## **TECHNICAL BULLETIN: 13-24**

DATE: August 28, 2013

SUBJECT: X2 Docking Board Dip Switch Settings

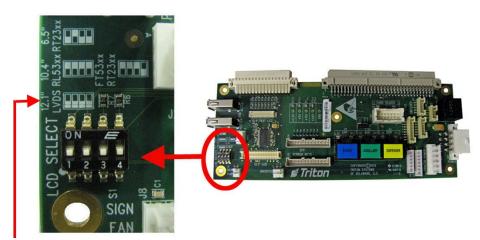
With the introduction of the ARGO unit, Triton is combining inventory and reducing the unit specific parts available. All the RL53 are now being built with docking board 09100-00153. The Docking Board Assembly **#06200-00159** is no longer available; instead order part **#09100-00153**. The new board is backwards compatible however there is a slight change in the Dip Switches.

The previous board had 5 dip switches to set. The new board only has 4 dip switches. To avoid confusion, a guide has been printed directly on the board showing to how to set the switches depending on the unit configuration.

(photo above shows the switches set for the 12.1" display, all switches in the OFF position)
